State of California
Department of Industrial Relations
Division of Occupational Safety and Health

# Memorandum

Subject: Evaluation of Petition No. 570 to Amend title 8 section 1710

Picture 1: Bar and cone barrier system in use

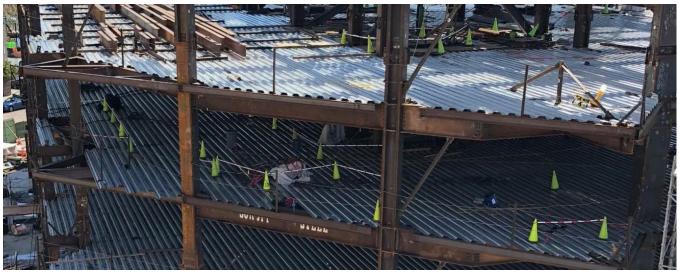
The CBB system recommended by the petitioners consists of high-visibility traffic high cones with connecting solid bars made of plastic or other similar material. The CBB system would be used only to warn employees about the presence of floor openings and does not create a physical barrier capable of withstanding any significant force. The pictures below show the CBB system.

The use of CBB system can be safer than covers when employees must access an opening repeatedly over a short period of time. Without the CBB system, each time employees begin work in an opening they must remove the cover, and each time they stop working in the opening, they must replace the cover. Employees are exposed to falls when removing or placing covers if they are not protected with a personal fall protection system. Guardrails cannot be used to protect employees who place and remove covers, as the guardrails would obstruct the work. The use of the CBB system, where there is a need for frequent access to an opening, can eliminate the repeated removing and replacing of covers and reduce exposure to falls. In these cases, the CBB system would enhance employee safety provided employees are effectively trained to not bypass CBBs and employers effectively establish and enforce the CBB system.

The CBB system is less protective than covers over openings when there is no need to frequently remove and replace covers over openings. The CBB system is a warning system only and can be easily bypassed. Employees who bypass a CBB will be exposed to falls. Where appropriate covers are continuously in place, they provide superior protection as employees are protected from falls through the holes at all times.

Possible additional hazards not addressed in the proposal when using a CBB system include vertically in-line openings at multiple levels. An employee or falling object could fall much greater distances if there are multiple holes on successive levels. The proposal also does not address fall protection for employees who work within the CBB area, prohibiting entry of unauthorized persons into CBB areas, and the covering of openings once work is complete and prior to allowing access by other trades.

The use of CBB systems should be limited to situations where work is in progress that requires floor openings to be uncovered. The proposals to specify the distance of barricades from openings, require warning labels on CBB systems, and require training of employees should be considered. The proposal to clarify in subsection 1710(I) that the provisions of subsection 1635(c) apply to decking and planking during structural steel erection work should also be considered.
